Access Compliance Report Public Rights-of-Way (RR Crossings)

Intersection ID: 10038349	Main Street: SOUTH_BV	Location: N/A
ADA ID: 8D10D4A83E13	Overall Compliance: No	Severity Score: 0.0
Codes/Mitigation Info/Possible Solution		Field Measurements/Component Compliance

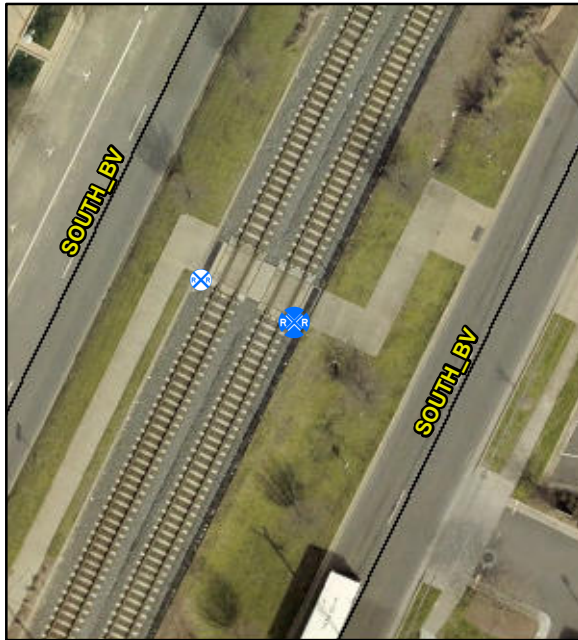
Remove & Replace Detectable Warning System. Provide Pedestrian Gate. Remove & Replace Walking Surface Adjacent to Rail.

R302.7.4, R305.2.5

Compliance	Description	Data
Yes	DWS Provided?	Yes
Yes	DWS Contrast?	Yes
Yes	DWS Width (in)	Yes
Yes	DWS Length (in)	25.0
No	DWS Offset (in)	7.0
No	Pedestrian Gate?	No
N/A	DWS Outside Gate?	N/A
N/A	Rail Type?	LightRail
No	Flangeway Gap (in)	3.0
Yes	Sidewalk Width (in)	120.0
